Kind: Improvement

Subject and reason: The activity of the ASW 15 during a long time has shown that the push-pull rods and their guides in the main bulkhead become dirty and sticky in their movement, especially when the airfield is dusty. There may also be a possibility for ice, snow, and dirt to freeze on the rods on cold and wet weather.

Effectivity: All ASW 15 to serial number 15 139 inclusive.

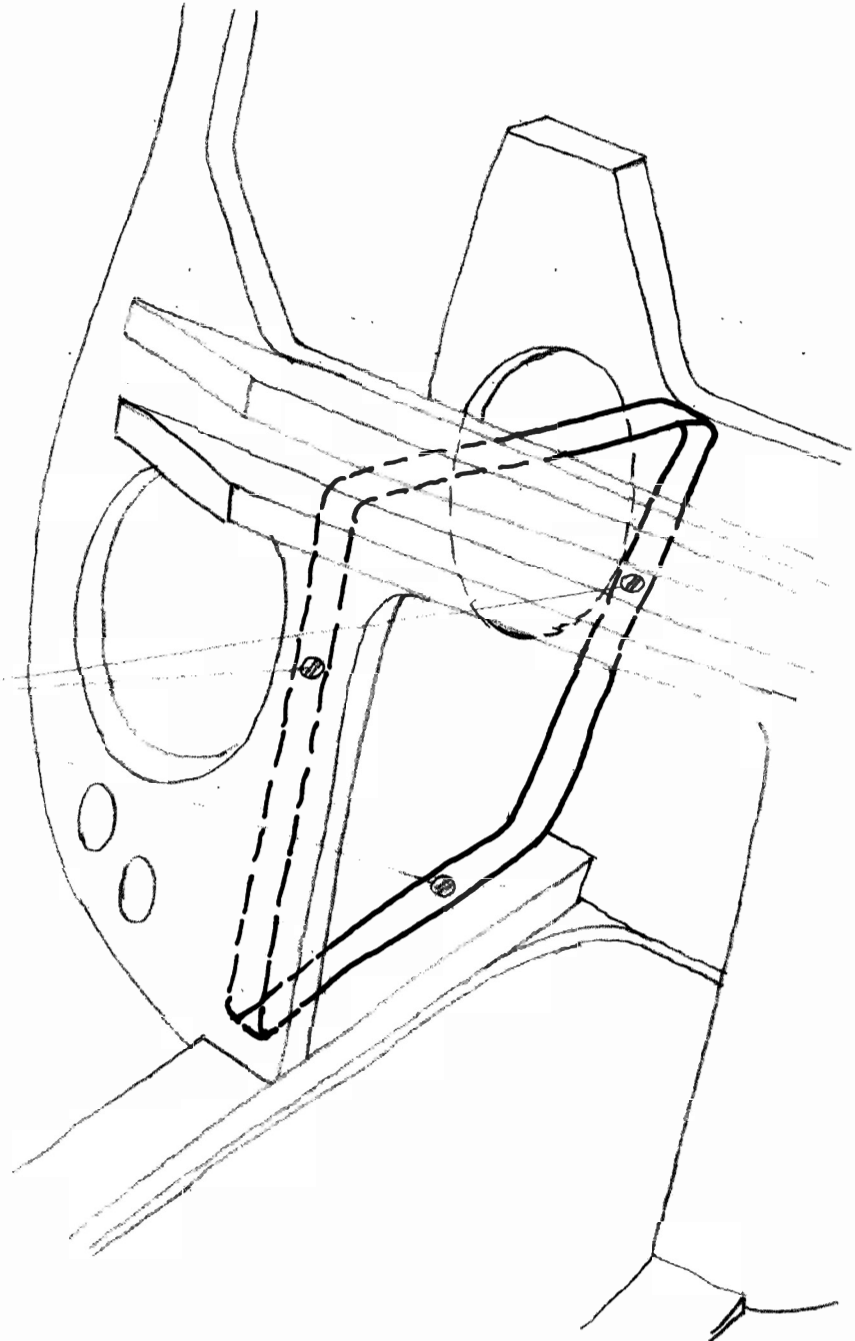
- Instructions:
1. Buy the FRP dust cover incl. 3 brass screws and washers from the Schleicher factory.
 2. Remove both halves of the baggage room.
 3. Clean the push-pull rods of the elevator and the ailerons in the cockpit and landing gear area, and grease.
 4. Fit the FRP dust cover between main bulkhead and middle bulkhead in such a way, that the holes for the O₂-bottles are just in full size. If the fuselage is standing vertically, the cover must also be installed vertically. The holes for the brass screws are marked on the FRP dust cover.
 5. Install the baggage room again.
 6. Check the controls for easy movement of the control rods.

*Fixing with
brass screws
for wood; and
also use washers.*
